LISTED BUILDING
CONSENT

Project Title:
107 High St, Lindfield, Haywards Heath, West Sussex, RH16 2HR

Drawing Title:
Detail Drawings:
Removal of Rooflights

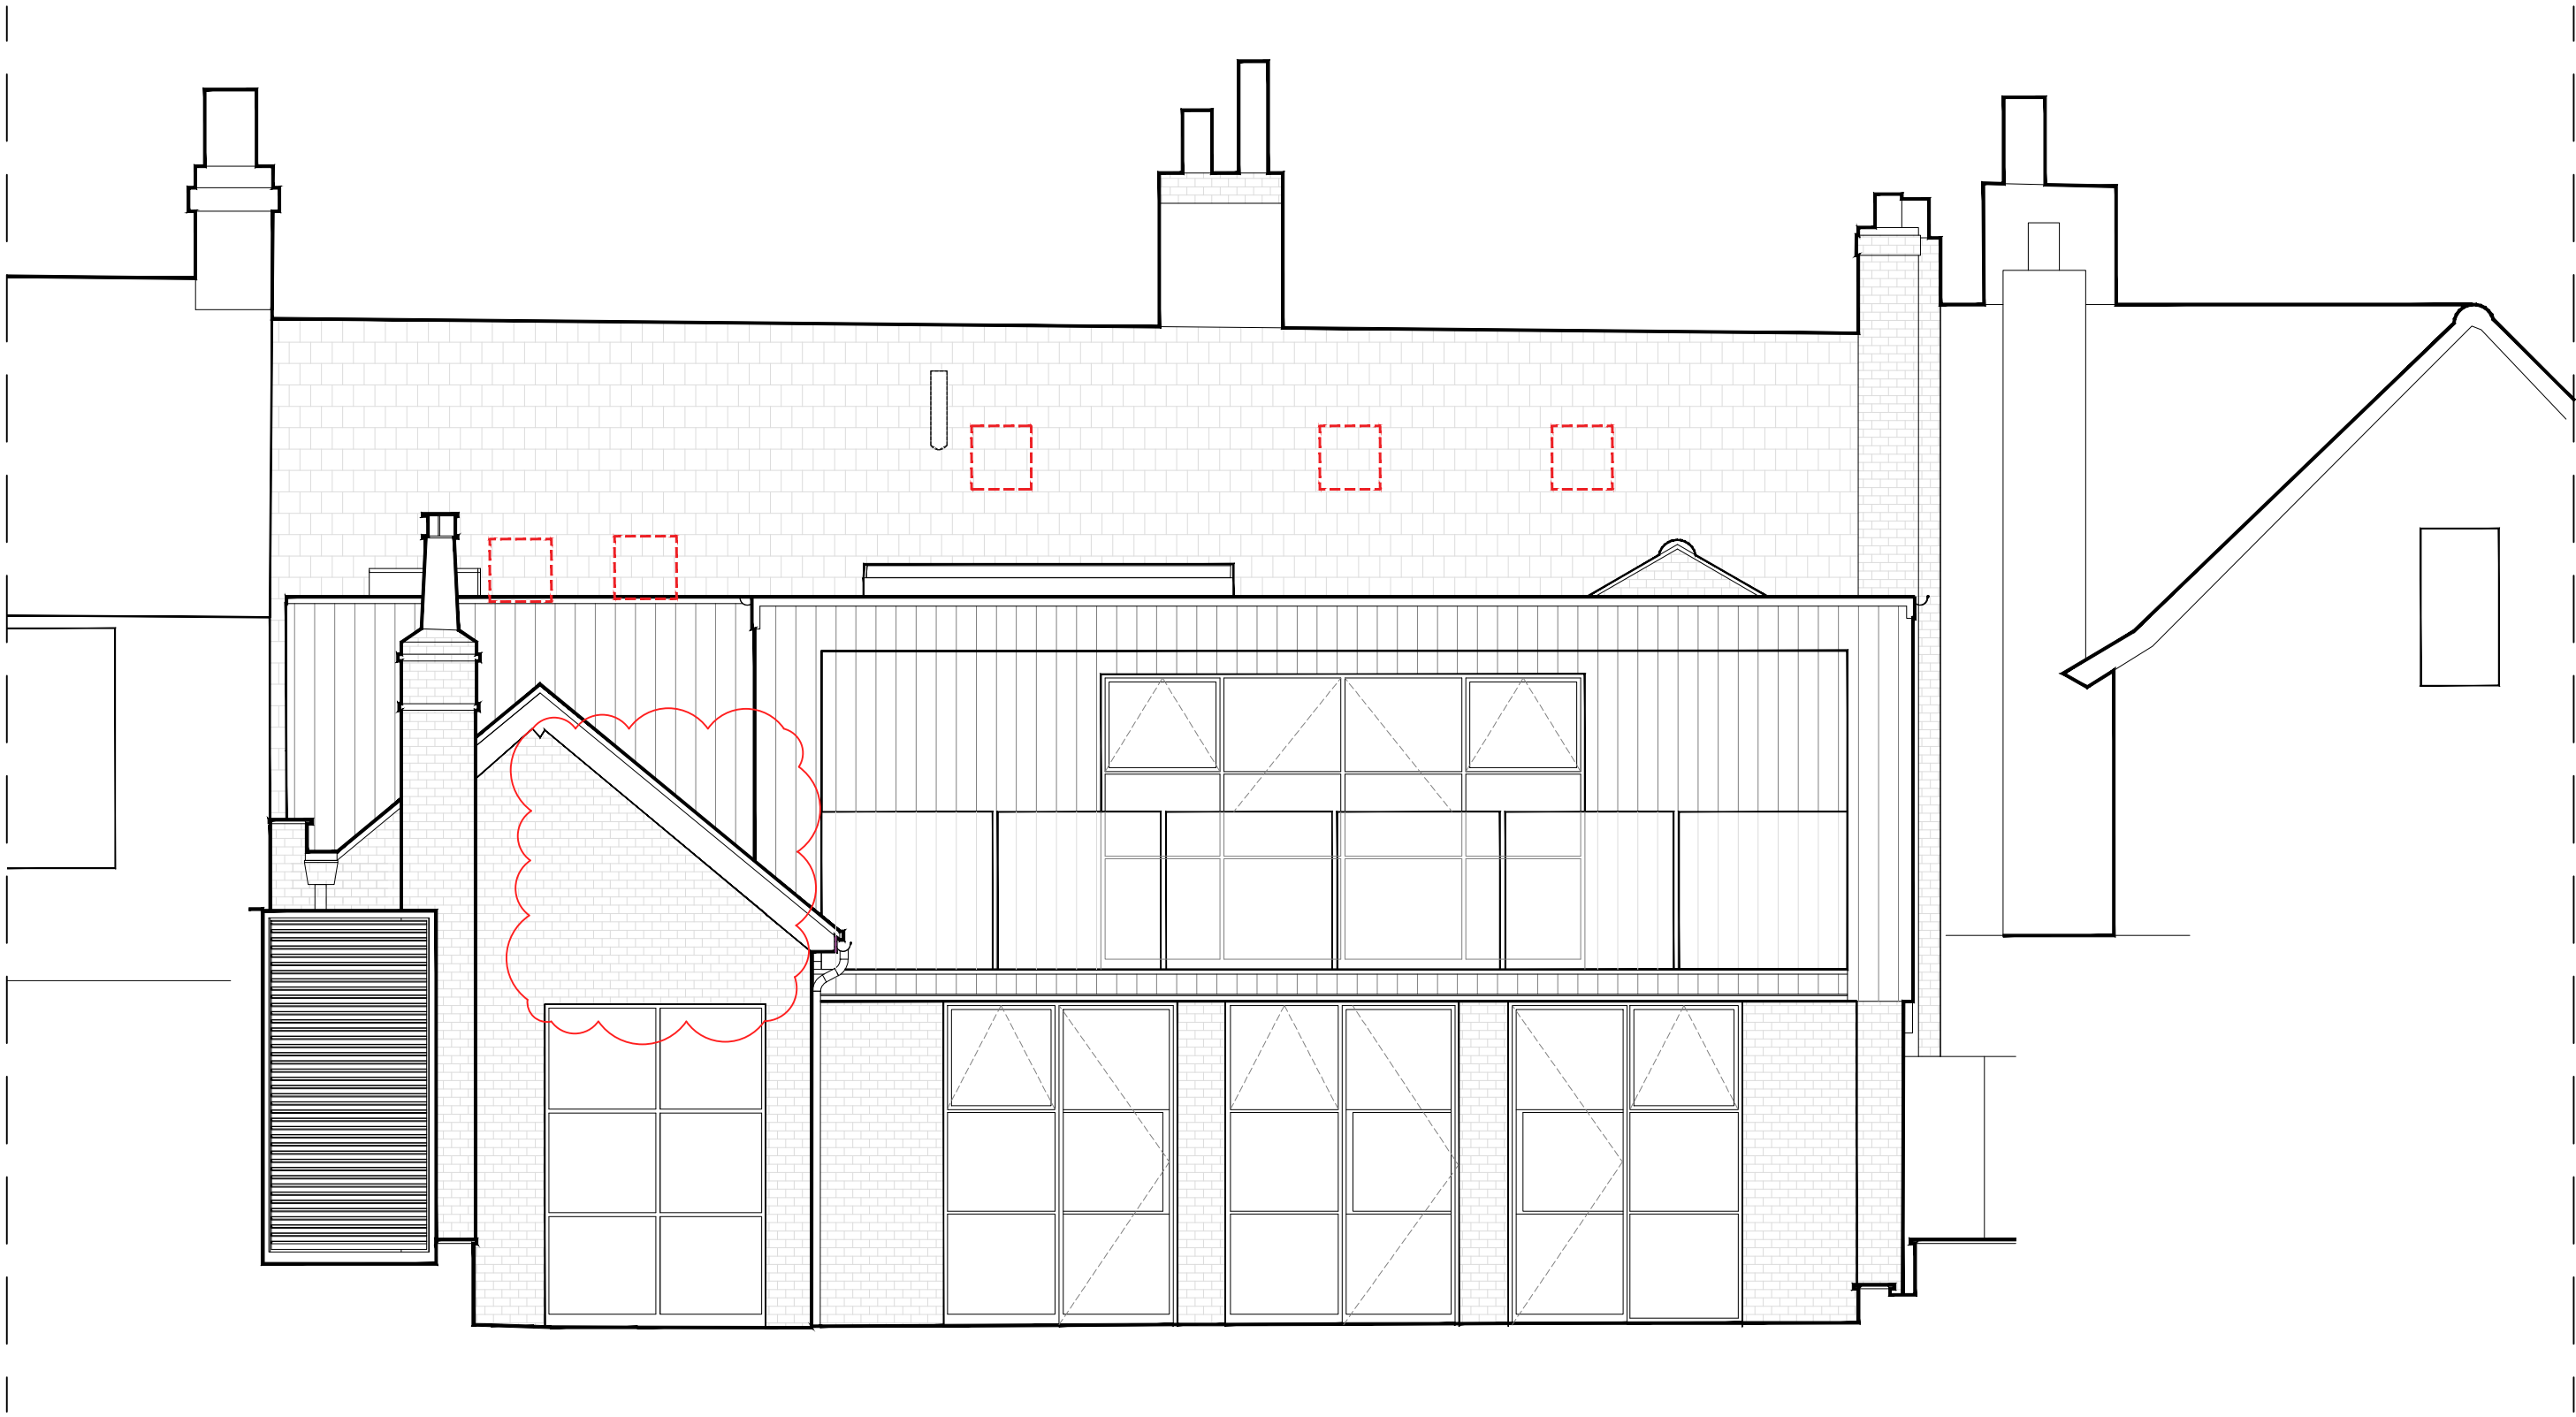
KEY:
Highlighted difference between Approved Scheme and 'As-Built'/Proposed Scheme

Rev.	Comments:	By:	Date:
A	Amendments as clouded.	KN	Nov 25
